**Traffic and Transport Expert Evidence  
Glen Eira Planning Scheme Amendment  
C155**

22 November 2019

Glen Eira Planning Scheme Amendment C155

SCALE 1:500 (A3) 0 2.5 5 7.5 10 SHEET No. 6 of 6 DWG No. G24360-B-07

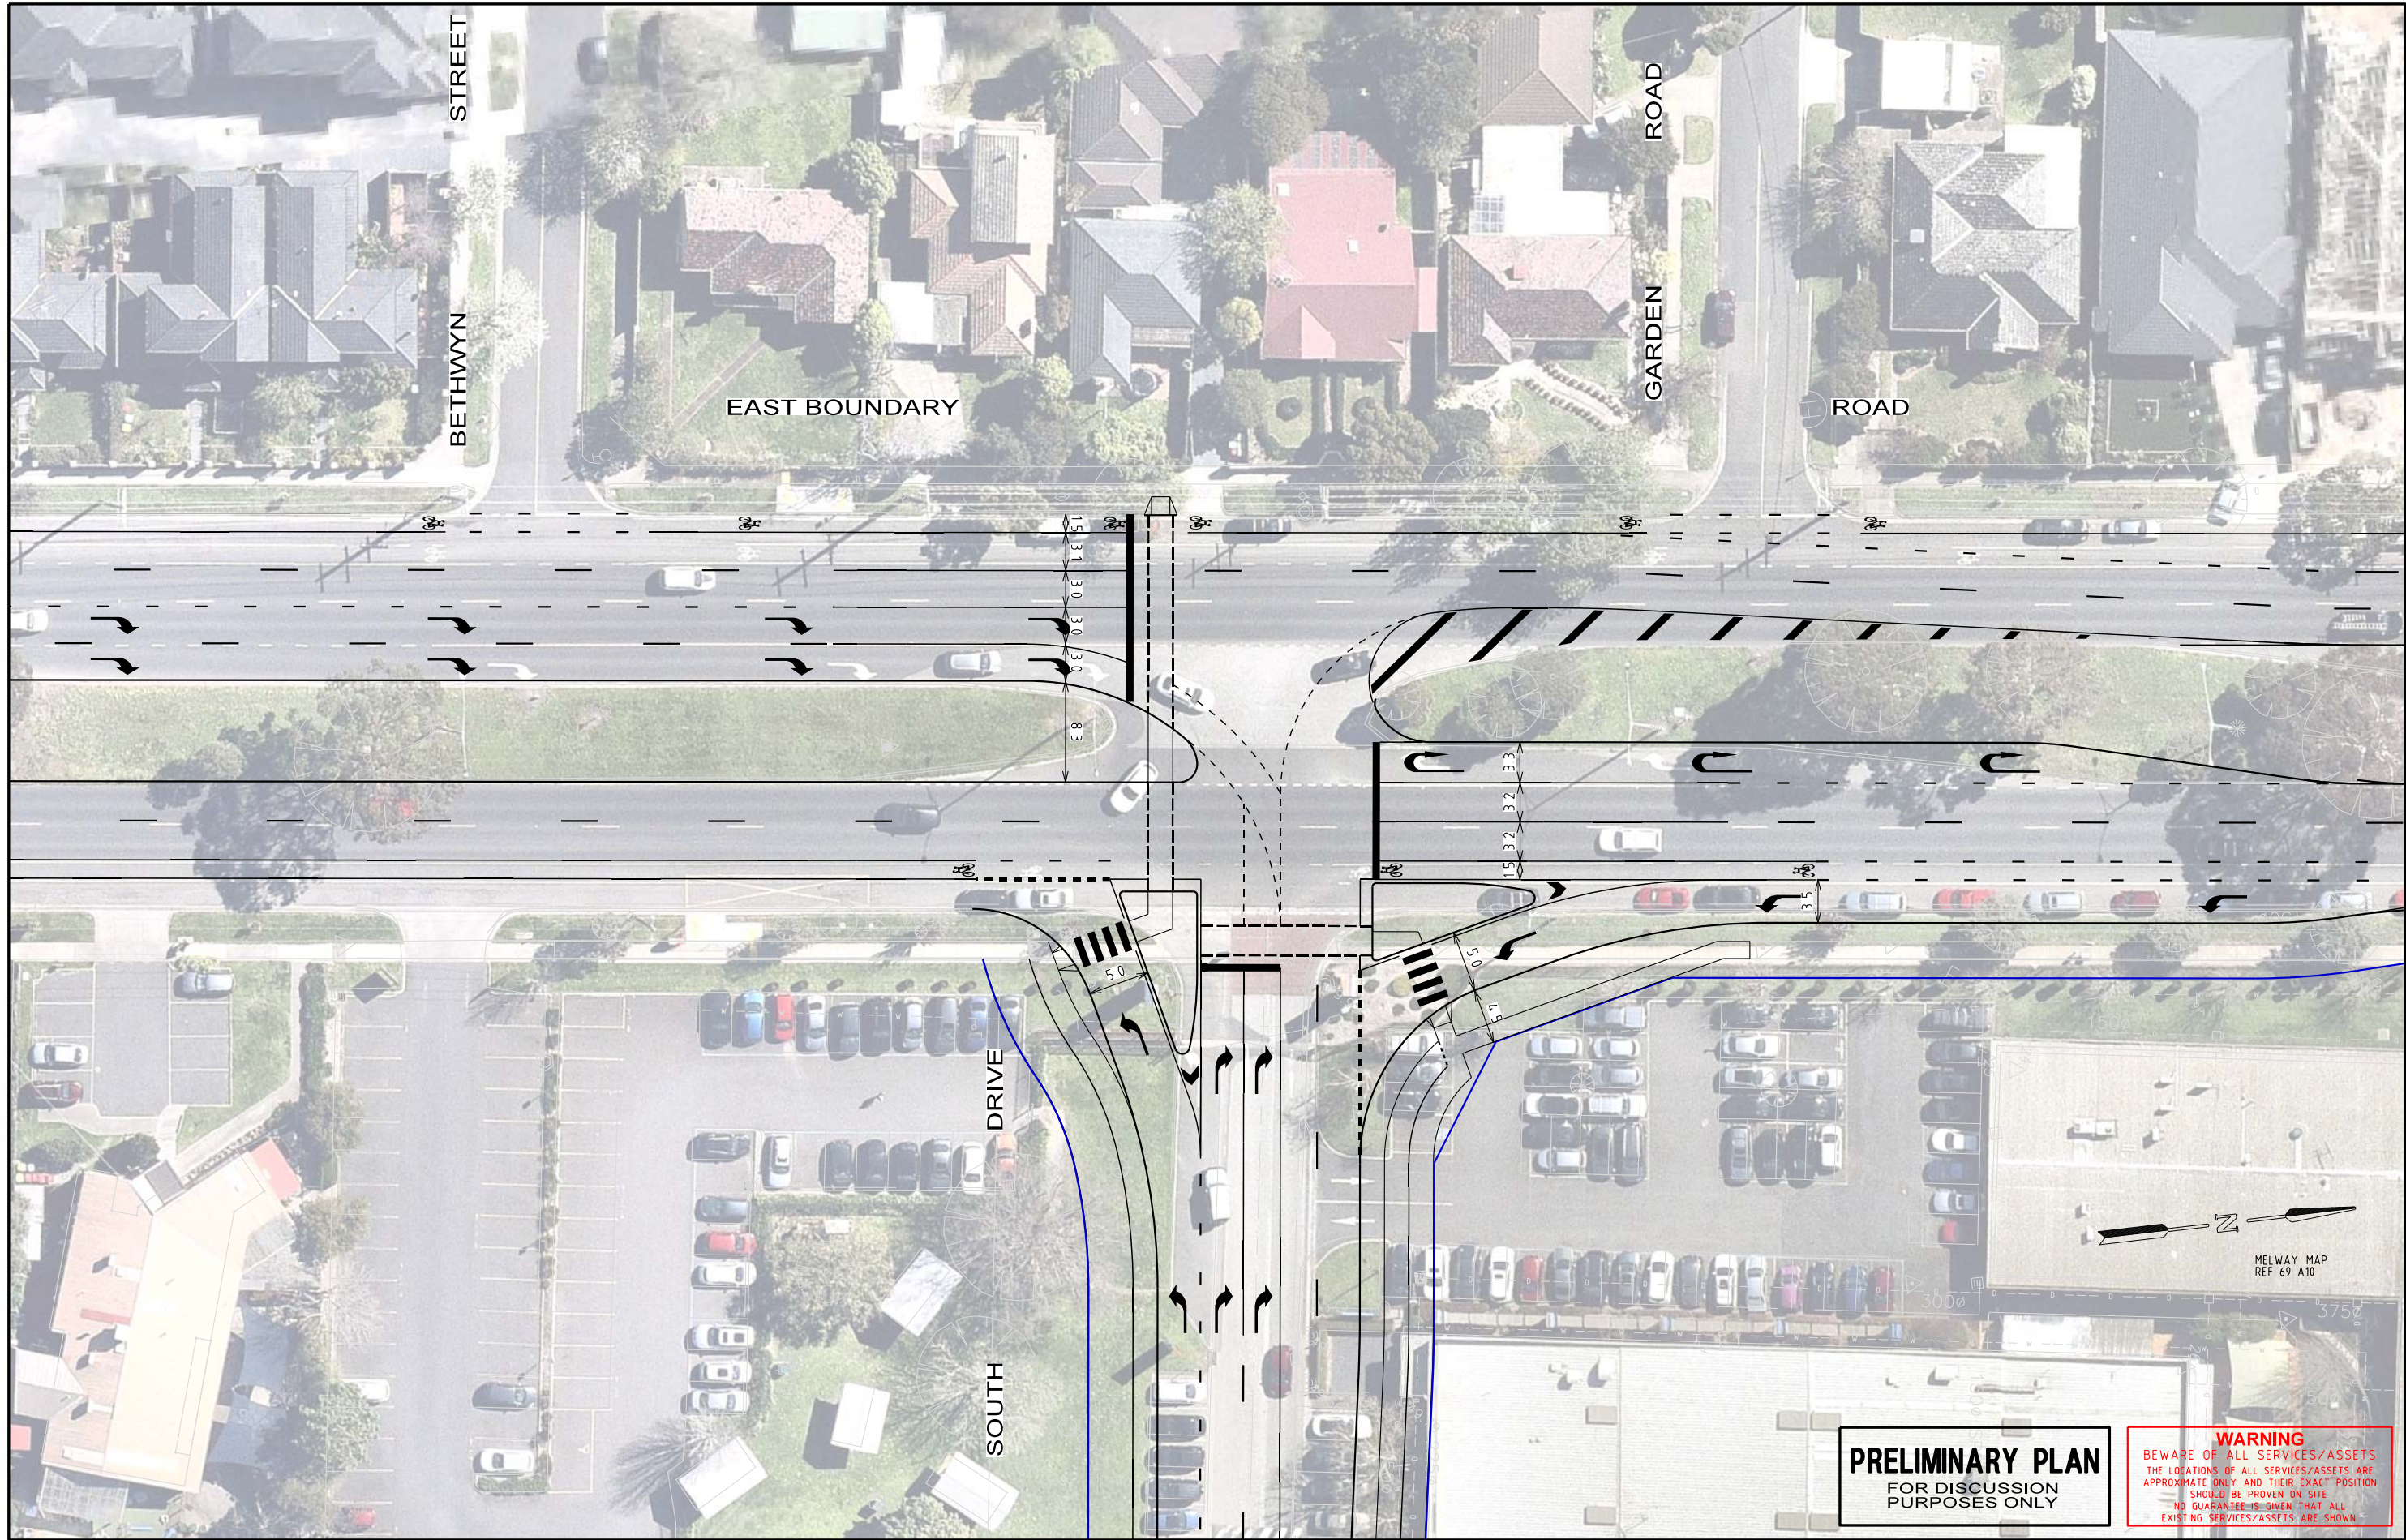
- 5.6.4 The revised proposal prepared by Traffix Group (Plan G24360-B-07) proposes to retention of two through lanes in East Boundary Road through the intersection of South Drive.

- 5.6.5 I have reviewed the revised proposal and accompanying analysis undertaken by Traffix Group as documented in the memo of the 18<sup>th</sup> November 2019 and am satisfied that the deletion of the third lane as proposed will significantly impact on the operation of the intersection as the predominate access point to East Village, or the overall operation of East Boundary Road past the site.
